RE: North Eden Creek - Reissued For Construction Plans & Specifications

All,
We've had a few questions come in on the updated plan set. Please see the questions and responses below in red:

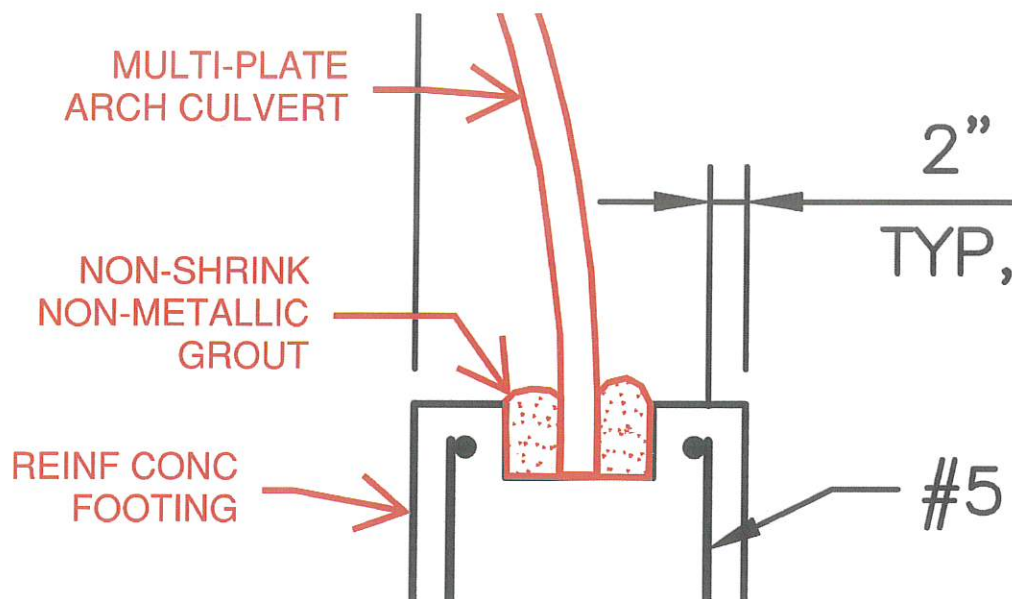
- Will any grouting other than defects in the concrete consolidation be required?
 - Yes. Once the multiplate arch pipe has been installed, the 8” channel in the concrete footer will be filled in with non-shrink grout. See figure below.
